Meeting Minutes Transmittal/Approval
Unit Managers Meeting: Waste Water Pilot Plant RD & D Permit

Meeting Held February 6, 1992
Environmental Protection Agency Region 10
1200 Sixth Avenue
Seattle, Washington

WASTE WATER PILOT PLANT RESEARCH, DEVELOPMENT, AND DEMONSTRATION PERMIT APPLICATION
NOTICE-OF-DEFICIENCY RESPONSE TABLE
APRIL 1992

Figure 1-1: Overall Process Flow Diagram

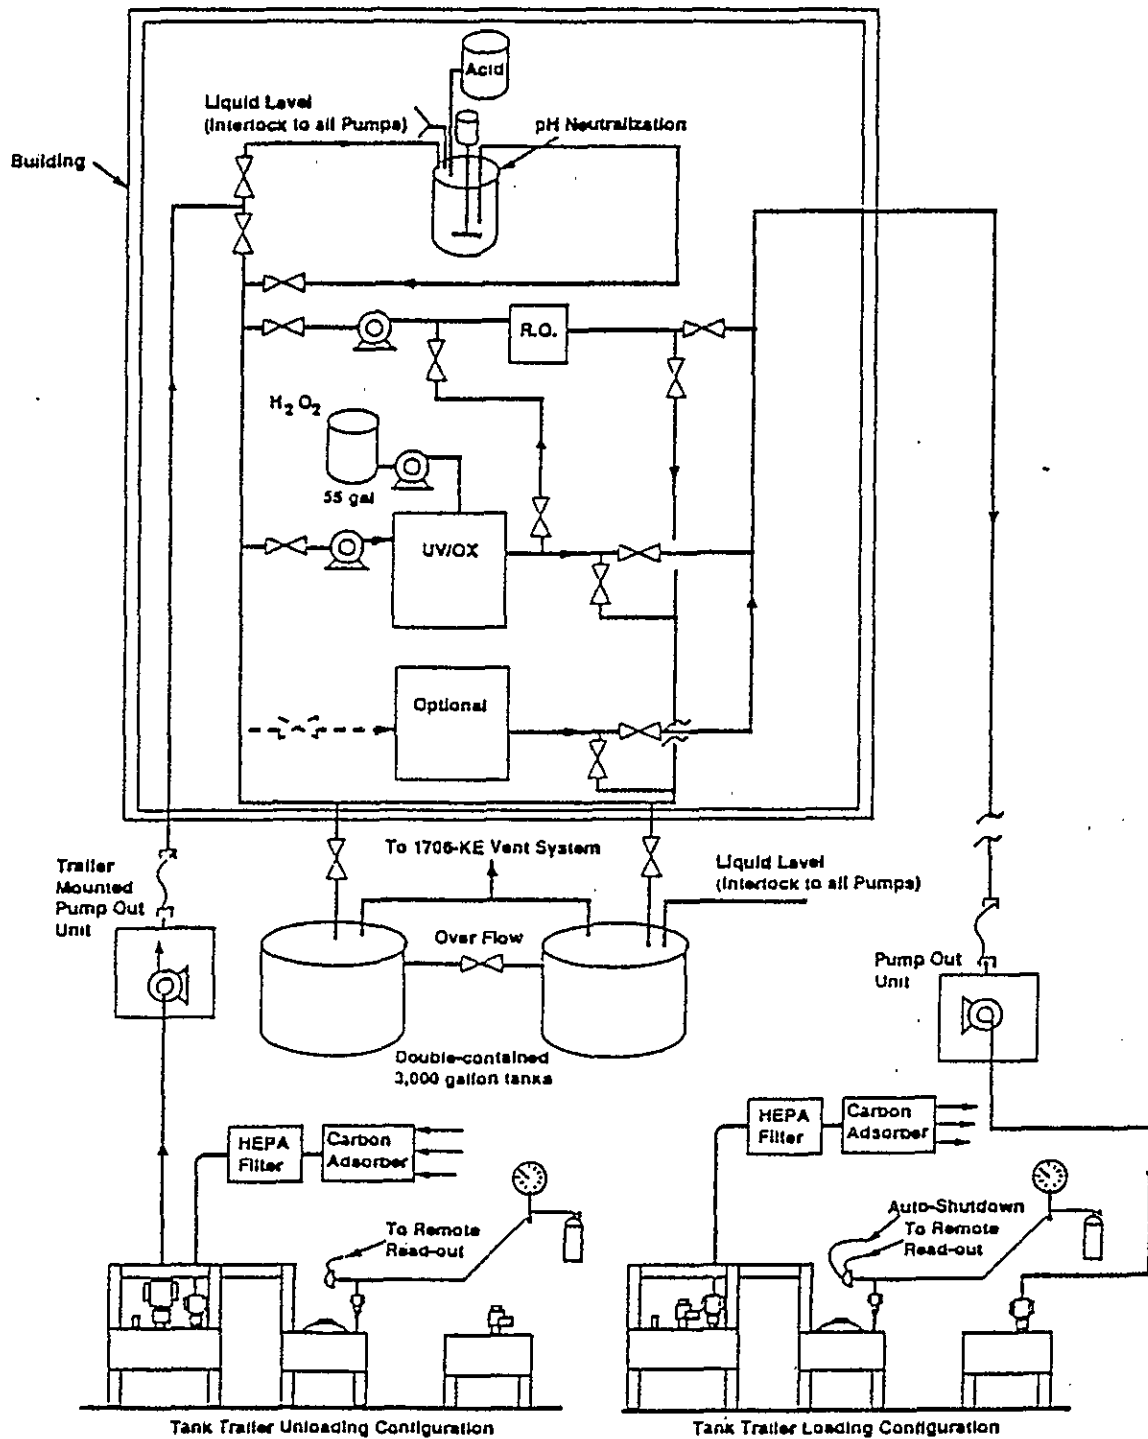
2.	<p>Critical Parameters: 40 CFR § 270.65</p> <p>a. Figures 4-1 through 4-19 should include both the range of the specific parameter being measured (e.g., temperature, pressure, etc.) and the set point/range which is established for that parameter. In addition, the pH limitation of the specific unit should be identified (i.e., the specific limit which would be unsafe should be specified). The Table 2-1 needs to be tied into this Section regarding primary and secondary technologies.</p> <p>DOE-RL/WHC Response:</p>
